# Memorandum

To	Douglas Shire Council and Department of State Development, Manufacturing, Infrastructure and Planning		
From	Sarah Wilson - GHD	Tel	+61 7 5413 8133
Subject	Response to information request from Douglas Shire Council (DSC) and Department of State Development, Manufacturing, Infrastructure and Planning (DSDMIP) Wangetti Trail SP1 - Combined Development Application Response to request for information 1909-13127 SRA	Job no.	4132458

We refer to the Development Application Council Ref: CA3212/2019 and SARA Ref:1909-13127 SRA associated with the proposed Wangetti Trail SP1 and provide responses to the information request issued by Douglas Shire Council (DSC) and Department of State Development, Manufacturing, Infrastructure and Planning (DSDMIP) in accordance with Part 3, Section 13.1 of the Development Assessment Rules.

**Figure 2 Marine Plant Disturbance**

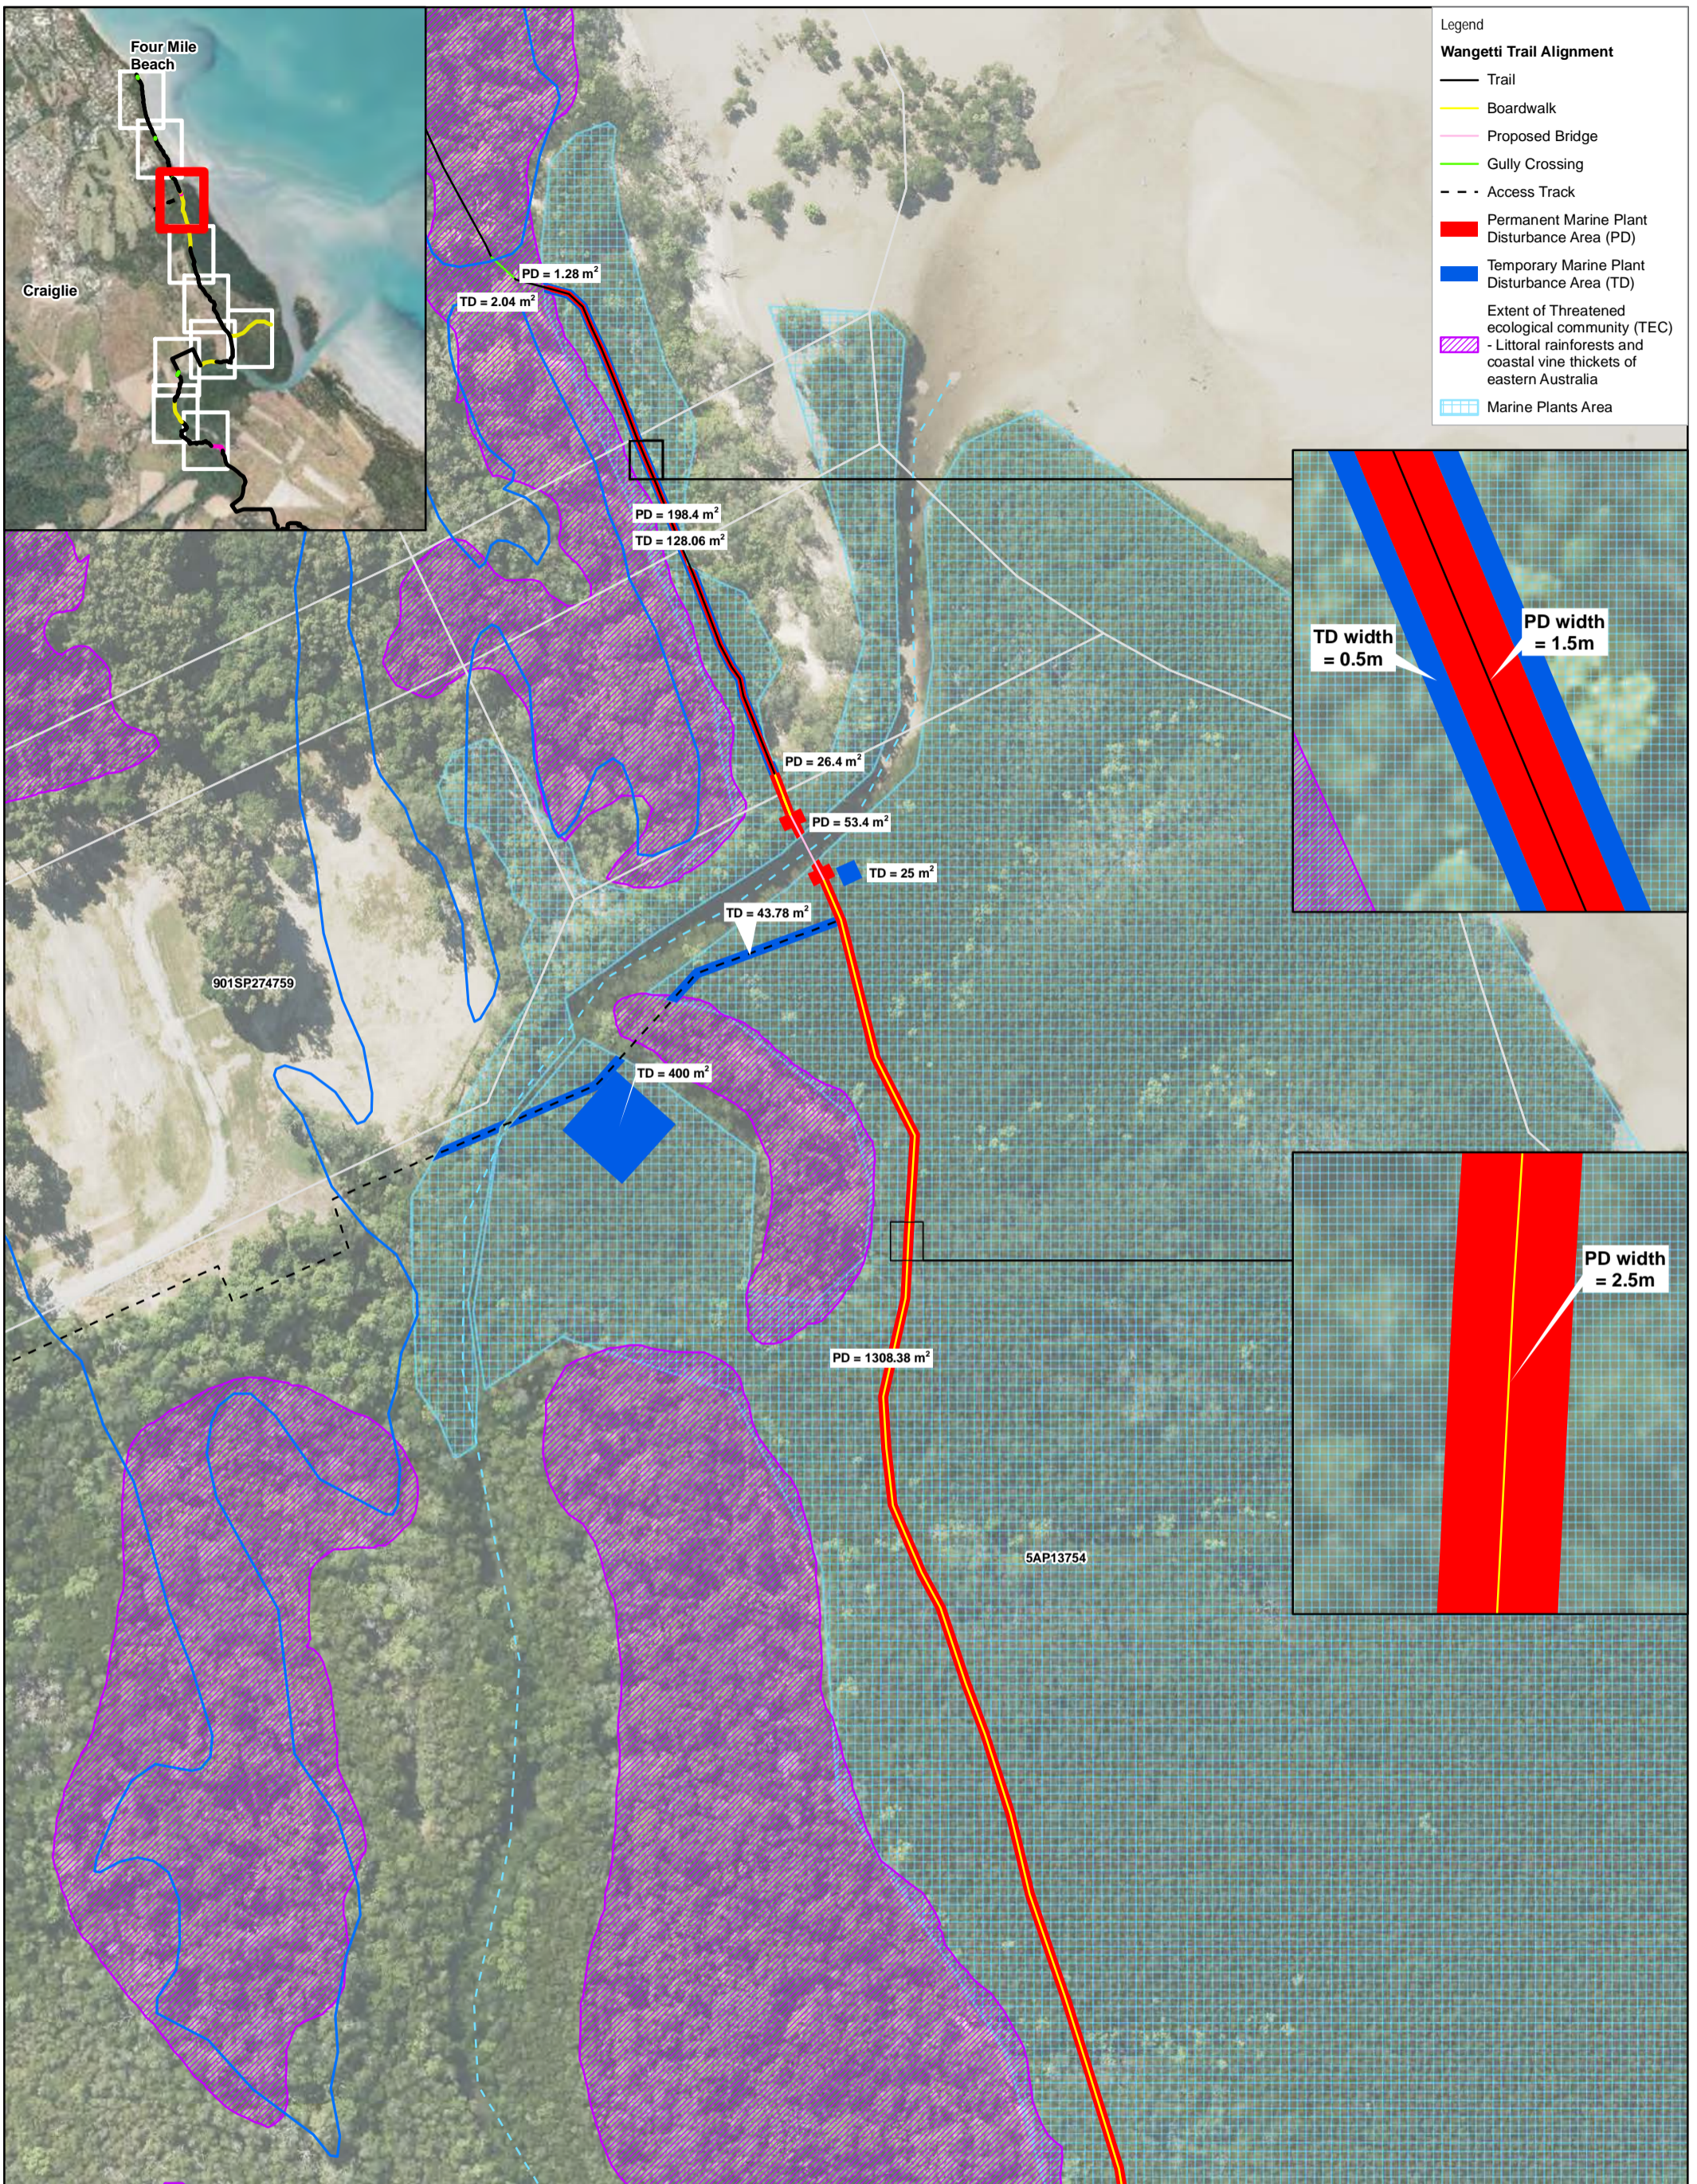
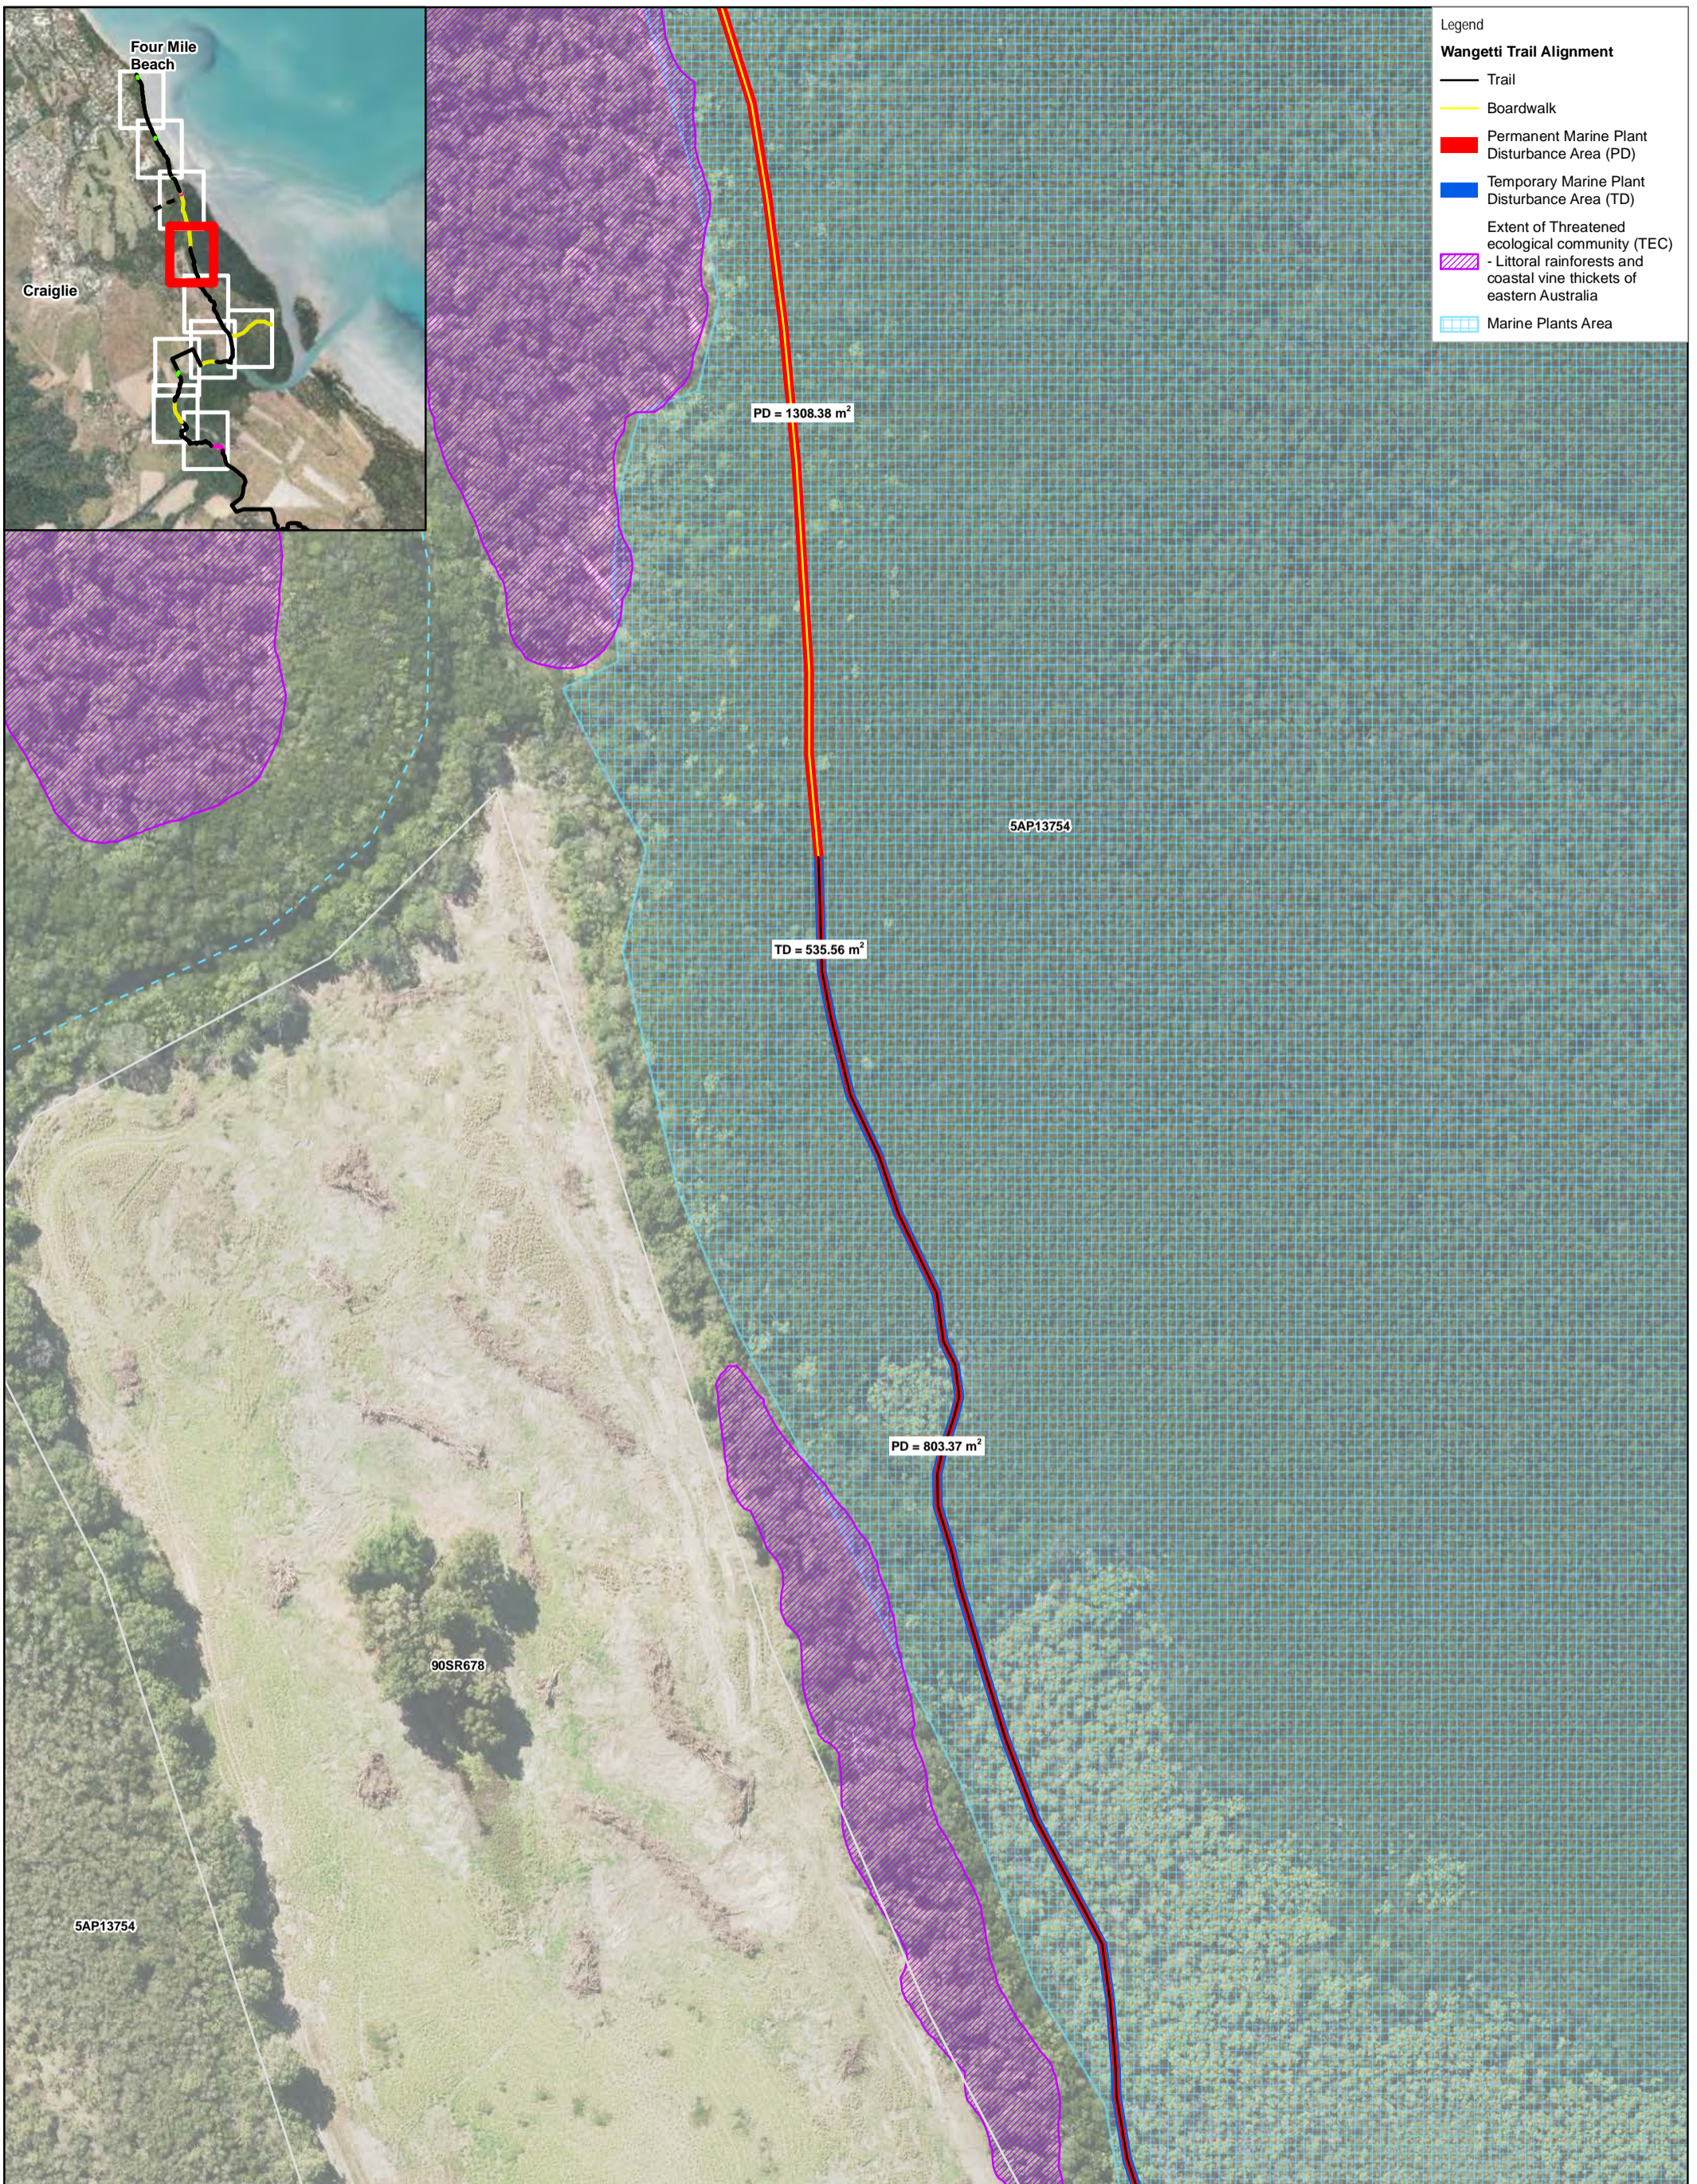
- b) *Provide maps identifying all locations where the trail will be constructed within TEC communities.*
- c) *Identify all locations where crushed rock will be used to construct the track and any creek crossings where rocks are proposed.*
- d) *Provide detailed information of the compacted trail construction and the impacts it will have to the existing profiles of tidal land.*
- e) *Demonstrate the compacted trail will not impact tidal flow and fragment tidal lands.*
- f) *Provide information of the existing tidal land levels (i.e. contour lines).*
- g) *Discuss the natural tidal inundation levels and connectivity of all adjacent habitat under elevated flow events. This discussion should include any impacts the proposed works will have on the existing connectivity.*
- h) *Discuss all potential impacts the proposed works will have on marine plants and fisheries resources.*

**Item 3 (c) Provide the individual marine plant disturbance area in meters squared (m<sup>2</sup>) for each works component.**

Figure 2 shows the location of the proposed trail and boardwalk and the location of threatened ecological community (TEC) - Littoral rainforests and coastal vine thickets of eastern Australia. The SP1 alignment has been designed to predominantly avoid areas of TEC, however the trail intersects with a small area of TEC, located approximately 600 m north of the Mowbray River. The TEC was not previously mapped in government databases and was recorded during the site investigation of the area. Based on the composition of the vegetation within the TEC area, it was determined not to contain high fisheries significant plants.

A breakdown of the marine plant disturbance including temporary and permanent disturbance has been provided in Table 3-2 of the Environment Assessment Stage 2 Wangetti Trail Planning Report for Operational Work - SP1 Marine Plant Disturbance Report and is outlined in Table 5 below and shown in Figure 2.
